DIXIE - NARCO, INC.
SERVICE BULLETIN # 114

Date: April 30, 1970

- a. Seventies Series Serpentine
- b. FN 408-6

B/M 155,010,100.04 Lock Support

FIG. A

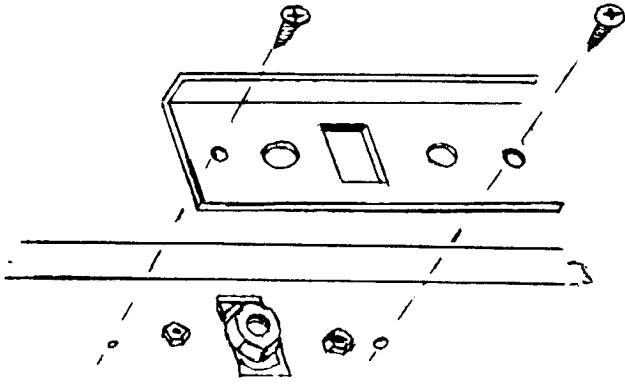
To Provide a Correction for "T" Handle Type Bolt-Lock Assembly when tightening of the "T" Handle (Possibly Excessively) results in a bind between threaded bolt and nut - - - the lock cannot be unlocked except with extreme difficulty or drilling out the plug lock.

1. LOCATE MOUNTING HOLES BY POSITIONING PARTS ON CABINET AS SHOWN. IF METAL IS WARPED AROUND LOCK NUT (FIGURE A) FLATTEN BEFORE POSITIONING PART.
2. MARK MOUNTING HOLES ON CABINET USING EXISTING HOLES IN PARTS AS TEMPLATES.
3. REMOVE PARTS AND DRILL WITH #30 (.1285 DIA.) BIT IN FIGURE A AND WITH #3 (.2330 DIA.) BIT IN FIGURE B.
4. INSTALL PARTS WITH SHEET METAL SCREWS.
